Staff Report

Infill Housing Design Review Committee

File Number: 3-M-22-IH

Location: 3429 Gap Rd. Parcel ID 81 | T 006

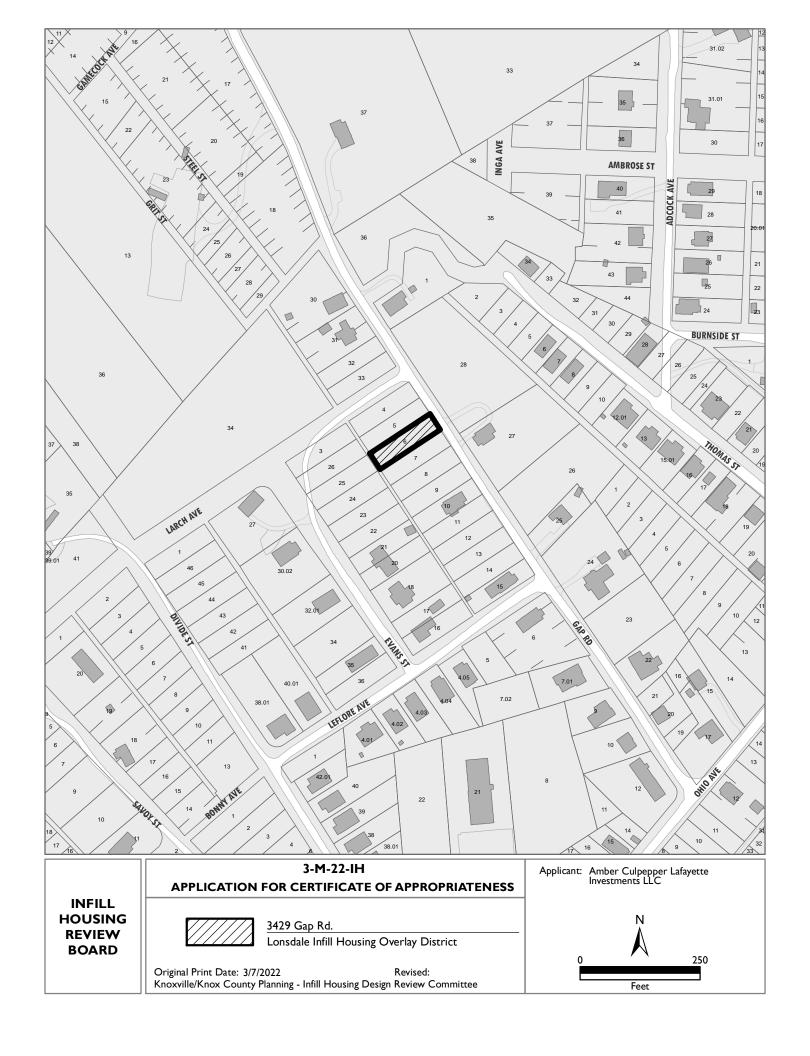
1. The proposed front setback is 28' from the front property line, with the front porch at 20' from the front property line. There are only three other houses on the block. 3401 Gap Road is located 42' from the front property line, and the new construction houses at 3405 and 3409 Gap Road are also set 42' from the front property line. The subject property is one of seven new houses to be constructed on the block, so the front setbacks will effectively create a new street pattern. The submitted site plans do not specifically call out the front setback measurement. Overall, the proposed front setbacks should be confirmed to create consistent front yard spaces along the block.

The seven adjacent new houses will demonstrate consistent side yard setbacks while accommodating the necessary side driveways. The applicant should confirm the left side exterior walls of all 7 houses will stay within the 5' side setback required allow windows on side elevation walls.

- 1) Front setback should be confirmed to create consistent front yard space along the block, with approval of final site plans by staff;
- 2) Left side setback to be a minimum of 5', so the left side elevations can retain windows;
- 3) Final site plan to meet City Engineering standards and Infill Housing design guidelines;
- 4) Add one bay of windows on the left side elevation, with approval by staff;
- 5) Final site plan to show one tree in front and one tree in rear yard.
